Overview: Production error in version 1.0 harnesses; The immobilizer wire (orange/black) is in pin position #4 instead of pin position #5. Although an effort to correct the issue was made, some quantity of harnesses did get shipped before the issue was spotted. We are advising to inspect the harness BLADE connector before attempting to install harness or program the module. This issue is not known to affect the version 2 harnesses, which require no modification.

Overview: Early versions of the FTI-STP1 harness require modification for **automatic transmission (AT)** applications, some of the product was able to be modified before release, but a small quantity was released without modification.

FTI-STP1: Installation and Configuration Notes

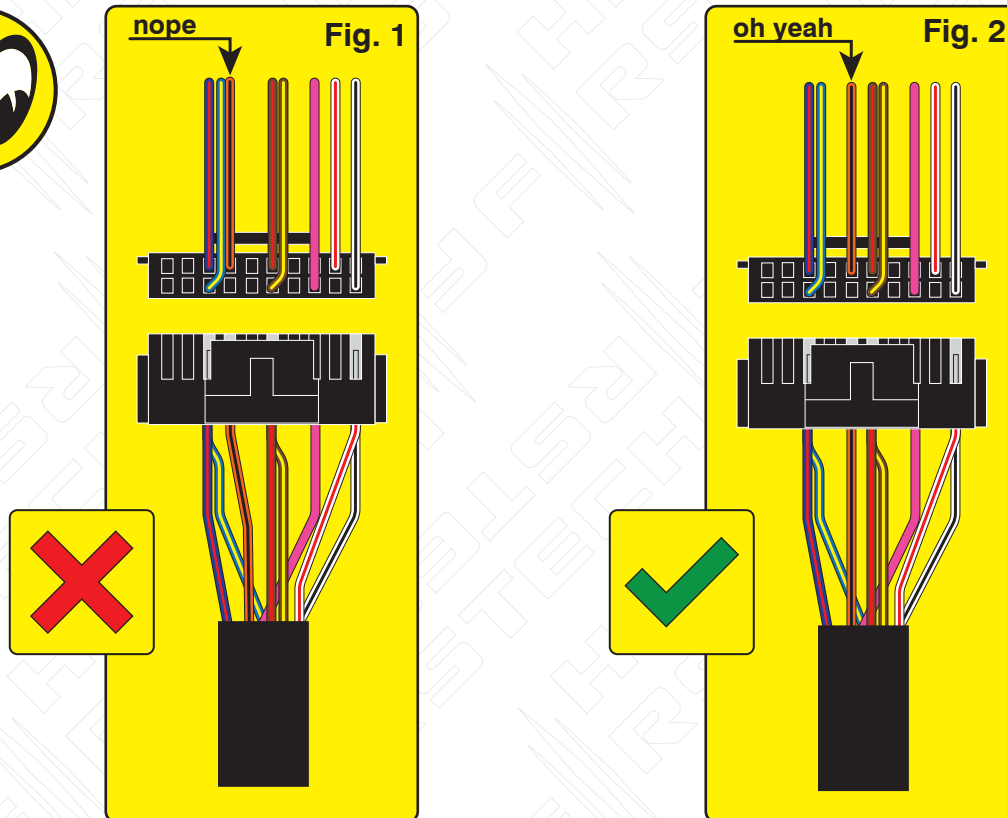
Issue: Module fails to program correctly to vehicle, does not allow the vehicle to be remote started.

Correction: Step 1.) Locate the orange/black wire and confirm whether it is positioned as illustrated in Fig. 1 or Fig. 2. If the wire is as illustrated in Fig.1, proceed with Step 2 through 5 and complete the repair procedure outlined, if the wire is as illustrated in Fig. 2, correction is not necessary, proceed with harness installation and module programming.

Step 2.) Using a pick, lightly depress the catch that secures the terminal in the housing then remove the wire and terminal from the housing.

Step 3.) Using a fine tip razor or utility knife, insert the blade beneath the terminal catch and raise it slightly, so that it can be reused to secure the terminal when reinserted into the BLADE connector housing.

Step 4.) Refer to Fig. 2 for correct position of the orange/black wire (next to brown/red) then reinsert the terminal, pressing lightly until the catch 'snaps' into place, securing the terminal in the connector housing.

Step 5.) The repair is complete, proceed with installation and programming.

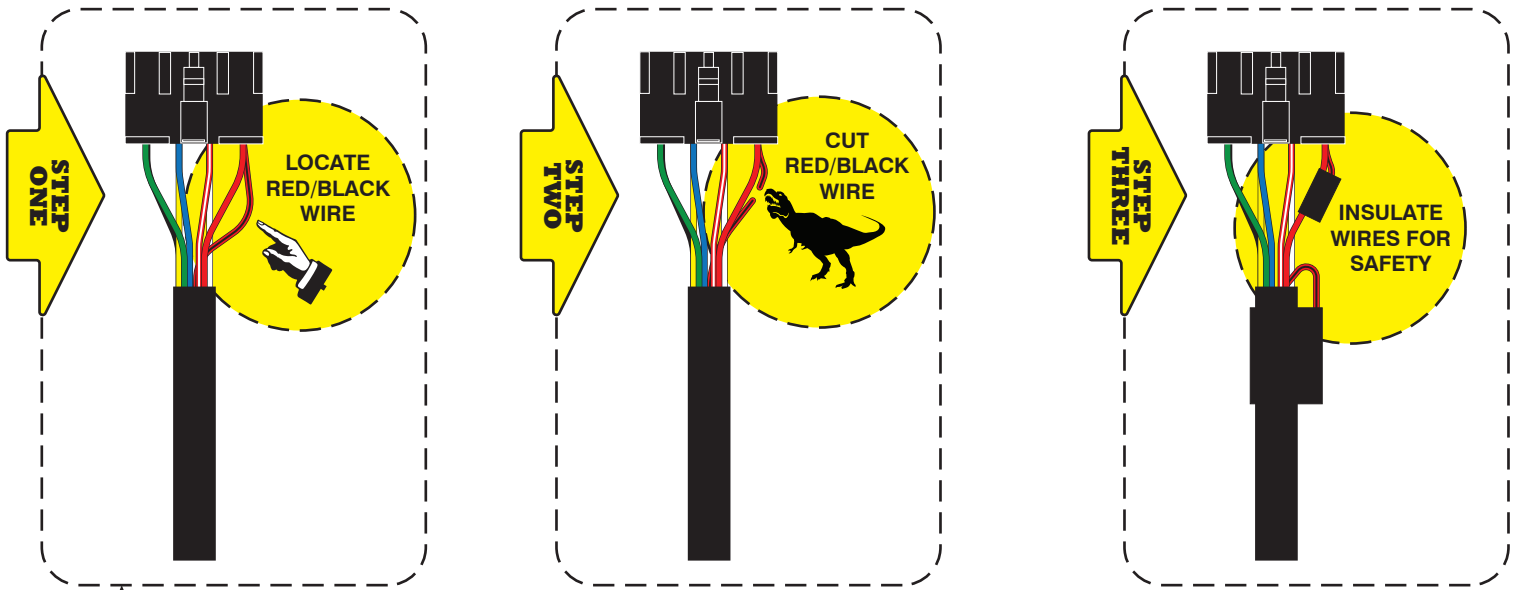
Issue: The FTI-STP1 T-harness has been designed to be compatible with A/T (automatic transmission) & M/T (manual transmission) applications, but due to an oversight in early production runs, the selection was defaulted to M/T mode.

Using a harness configured for an M/T application, in an A/T equipped vehicle, could result in vehicle module damage, it is advised that the harness be returned to A/T mode before installation in vehicles equipped with an automatic transmission.

Correction: Locate the **red/black (+ Clutch)** wire provided in the CN1 connector of the main harness assembly. Cut the **red/black** wire, either flush to the CN1 connector, or leaving enough wire exposed so that you can insulate and secure the ends of the wire that remain after cutting. Insulate each of the remaining ends of the **red/black** wire and secure to prevent any possibility of a short circuit. **If the red/black wire has already been disconnected, no further modification is required for A/T applications**

MODIFICATION REQUIRED FOR A/T APPLICATIONS, ONLY WITH v 1.0 HARNESS

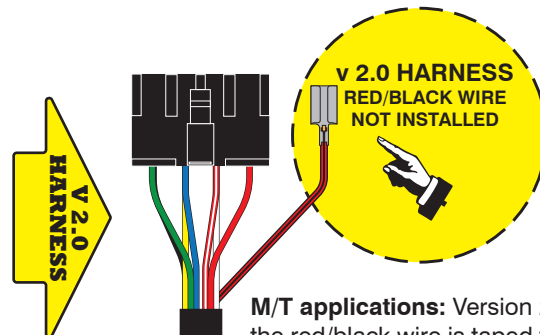
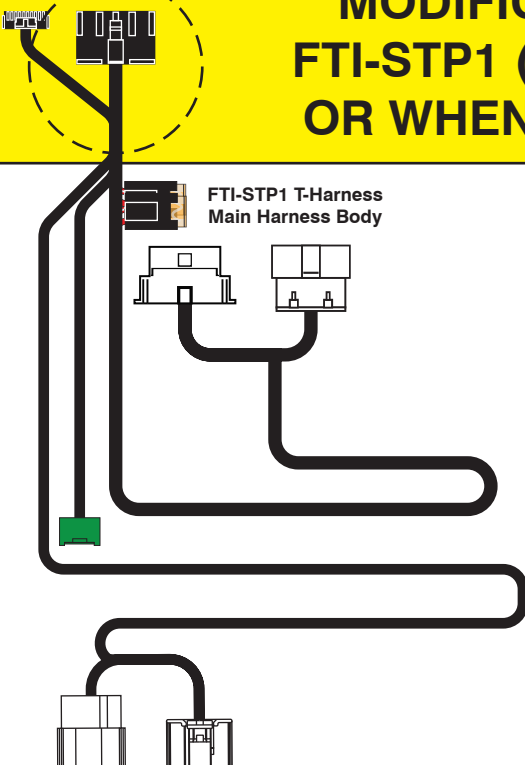
MODIFICATION NOT REQUIRED WHEN USING FTI-STP1 (v 1.0) HARNESS IN M/T APPLICATIONS, OR WHEN USING THE FTI-STP1 (v 2.0) HARNESS

M/T applications: Version 2.0 harness, the red/black wire is taped to the main harness when shipped, and must be installed in the CN1 connector when installed.

A/T applications: Leave the red/black wire taped to the harness, it is not required for A/T applications
